ARC REVIEW CODE: R2011231

TO: Chairman Mike Boyce
ATTN TO: John Pederson, Zoning Manager
FROM: Douglas R. Hooker, Executive Director
RE: Development of Regional Impact (DRI) Review

Name of Proposal: Circle 75 (DRI #3169)

Submitting Local Government: Cobb County

DRI SITE PLAN (EAST)

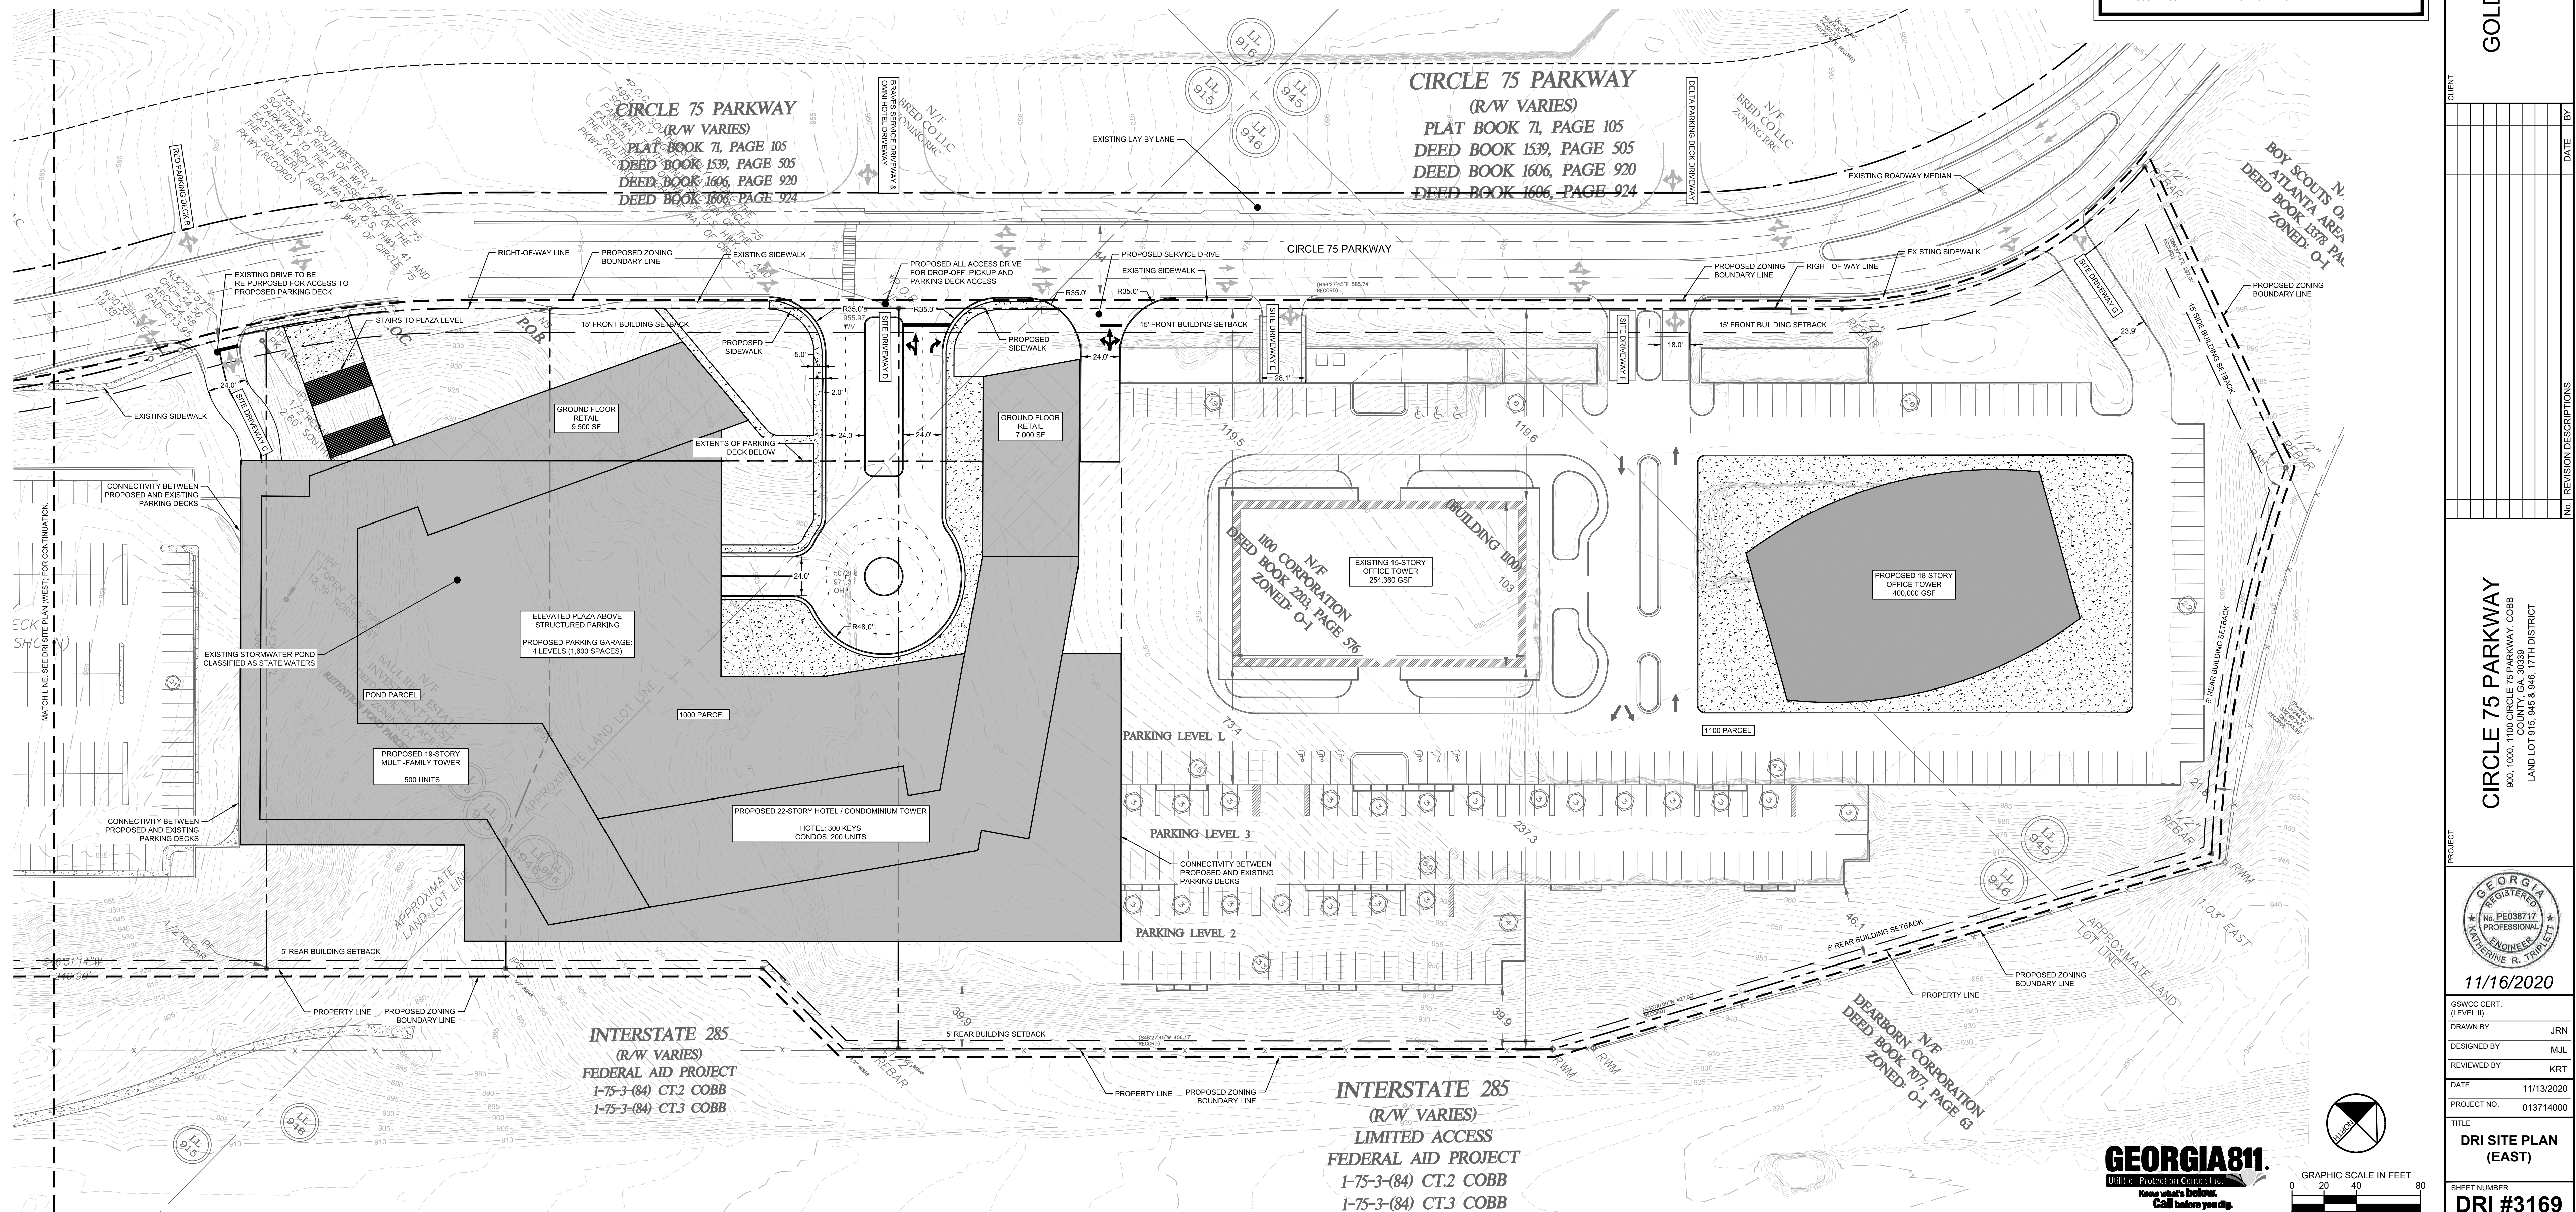
For example, the site plan currently shows existing sidewalks (approximately 4 feet wide, the bare minimum for ADA) and long curb radii (35 feet) that allow turning vehicles to carry high speeds into pedestrian zones and lengthen crossing distances. There is currently no legal or safe option for pedestrians to cross Circle 75 Parkway shown on the site plan, other than by accessing the existing pedestrian bridge located at the southwestern end of the site. The estimated walking distance for an office worker or event attendee who parks at the proposed new office tower at the northeastern end of the DRI site is 0.4 miles to the pedestrian bridge, then a similar distance back up to the nearest admission gate for the stadium. If the DRI is intended to serve the stadium development and vice versa, then additional pedestrian crossings must be provided.

The intersection at Site Driveway D and the Braves service driveway doesn't currently show a signalized intersection or pedestrian crosswalk. Another factor to consider for pedestrians and cyclists is the multi-use trail on the other side of Circle 75, which is a part of the Cumberland area's trail network and provides access to the Bob Callan Trail, Rottenwood Creek Trail, and the Chattahoochee River National Recreation Area beyond. The site is currently served by CobbLinc route #15, with two stops on either side. Future streetscape design should seek input from CobbLinc staff to locate these stops in the appropriate location for safe pedestrian crossings and provide shelters and other amenities.

There is a proposed service drive for the project area. However, it is unclear of the path delivery and service vehicles will use for turning around.
